UNITED STATES PATENT AND TRADEMARK OFFICE

APPLICATION NO.	FILING DATE	FIRST NAMED INVENTOR	ATTORNEY DOCKET NO.	CONFIRMATION NO.
10/749,822	12/31/2003	John Pafford	1842-0029	9366
28078 7590 01/08/2008 MAGINOT, MOORE & BECK, LLP CHASE TOWER 111 MONUMENT CIRCLE SUITE 3250 INDIANAPOLIS, IN 46204			EXAMINER HOFFMAN, MARY C	
			ART UNIT 3733	PAPER NUMBER
			MAIL DATE 01/08/2008	DELIVERY MODE PAPER

Office Action Summary	Application No. 10/749,822	Applicant(s) PAFFORD ET AL.	
	Examiner Mary Hoffman	Art Unit 3733

Schlapfer et al. (Patent 5,501,684)

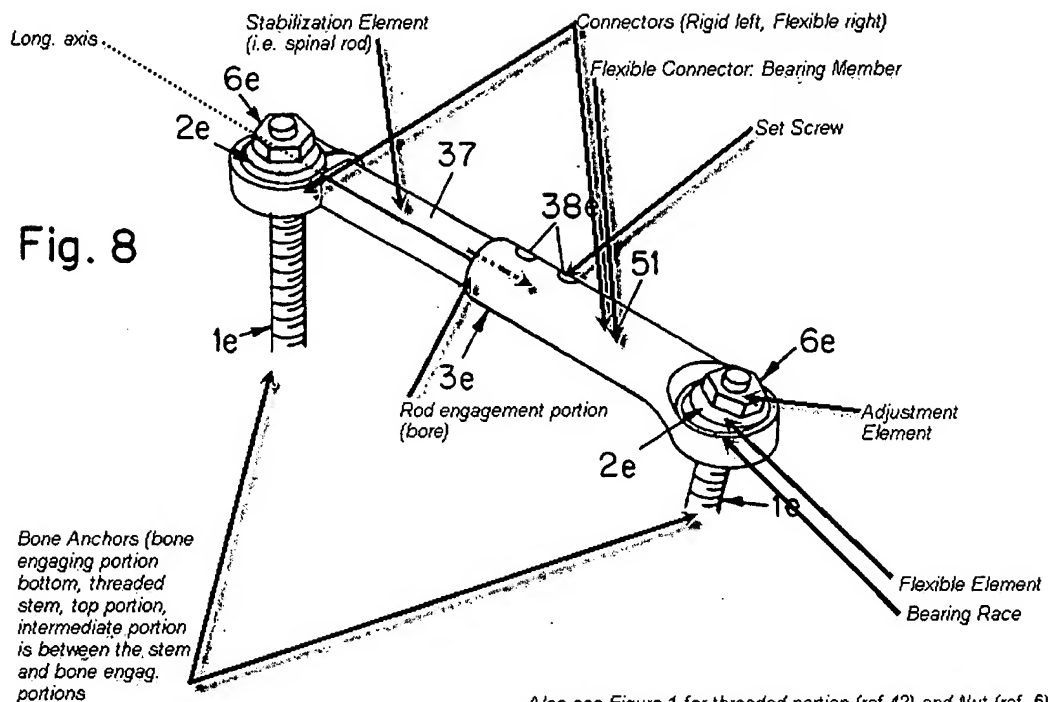
Schlapfer et al. disclose a dynamic stabilization system for stabilization comprising a stabilization element (FIG. 8, ref. 37) capable of spanning between at least two vertebrae and defining a longitudinal axis along the length of the element: at least two bone anchors (ref. 1e), each having a bone engagement portion (lower half); and at least two connectors (see FIG. 8, attachment mechanisms fixing ref. 1e to the stabilization element, ref. 37) for connecting a corresponding one of the bone anchors to the stabilization element, at least one connector including; a bearing member (ref. 51) attached to the stabilization element; a compressible flexible element (ref. 2e) supported within the bearing member with the bone anchor extending through the flexible element, the flexible element contacting the bearing member substantially along the longitudinal axis of the stabilization element to permit relative pivoting between the corresponding bone anchor and the stabilization element and the flexible element is configured to expand along the longitudinal axis as the element is compressed; and an adjustment element (ref. 6e) configured to compress the flexible element to thereby adjust the flexibility of the flexible element. The stabilization element includes an elongated spinal

rod, the bearing member is a rod end bearing including a rod engagement portion; and the flexible element is a bearing element of the rod end bearing. The bearing element is received within a bearing race (integral with ref. 51, the surface along circumference of the bore in which ref. 2e is placed) of the rod end bearing; and the adjustment element is arranged to compress the bearing element within the bearing race. The rod engagement portion includes a bore for receiving a portion of the spinal rod therein and a set screw (ref. 38e) for clamping the spinal rod within the bore. The at least one of the bone anchors includes a stem having a threaded portion (see FIG. 1, ref. #42); the flexible element includes a bore for receiving the stem therethrough; and the adjustment element includes a nut engaging the threaded portion and arranged to compress the flexible element as the nut is threaded onto the threaded portion. The at least one of the bone anchors includes an intermediate portion (see FIG. 1, ref. 11) between the stem and the bone engagement portion, the intermediate portion configured to support the flexible element so that the flexible element is compressed between the intermediate portion and the nut when the nut is threaded onto the threaded portion. Another of the connectors is configured to substantially rigidly connect one of the bone anchors to the stabilization element (see FIG. 8, left side). The at least one connector including a unitary bearing member. The flexible bearing element mounted within the bearing race. The flexible element has a substantially spherical outer surface; and the bearing race defines a substantially spherical inner surface engaging the outer surface of the flexible element.
